Sundry Notices and Reports on Wells

8.	Well Name & Number Boulder Mancos #1
3. Address & Phone No. of Operator #28 County Road 1490, La Plata, NM 87418, 505-326-6015	9.	API Well No.
Location of Well, Footage, Sec., T, R, M	10.	Field and Pool Boulder Mancos
660' FNL and 330' FWL, Sec. 26, T-28-N, R-1-W,	11.

13. Describe Proposed or Completed Operations		
Billco Energy plans to plug and abandon this well per the attached	ed proc	edure.
Well name when drilled in 1962 was the Jicarilla 4-26 #1

RLM CONDITIONS OF APPROVAL

Boulder Mancos #1 Well Jicarilla Apache 4-26 #1 Proposed P&A

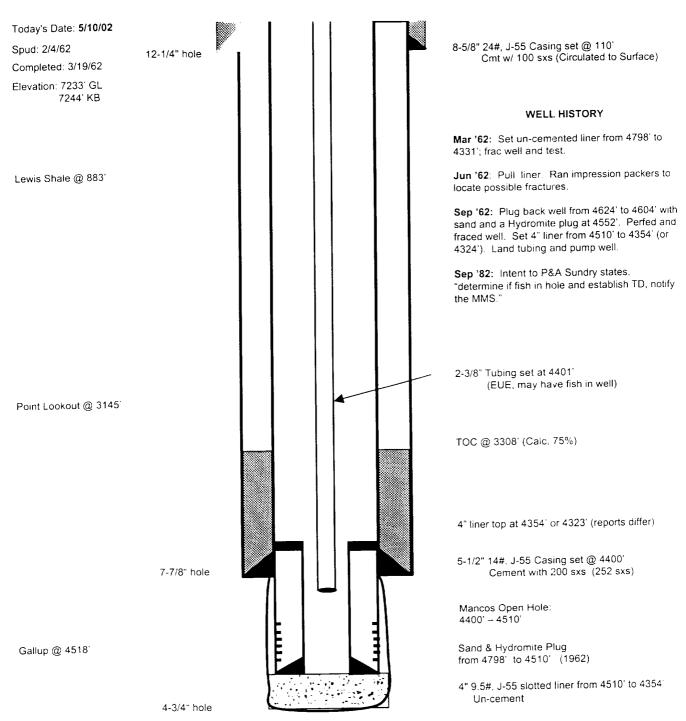
Isolate the Cliff House Sandstone (2200') inside and outside Of the casing.

A plug will be placed from 2300' to 2100' to isolate the Cliff House Sandstone at 2200'
